Access Compliance Report Public Rights-of-Way (Pedestrian Signals)

Main Street: KATELLA_AVE Cross Street: GARZA_AVE Location: SE

ADA ID: SGRK210920124842 Signal Type: One Push Button-Non APS Overall Compliance: No Severity Scores: BTN 1: 35 BTN 2: N/A No BTN: N/A

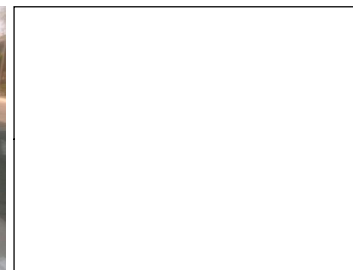
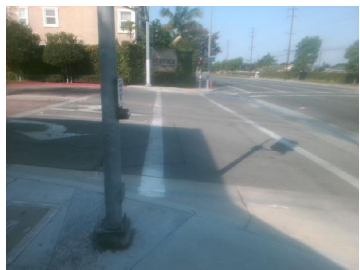
OC Std/PROW: R404.2, R404.3, MUTCD 4e.08

Possible Solutions: Replace Signal Push Button With APS Button. Remove and Replace Clear Space.
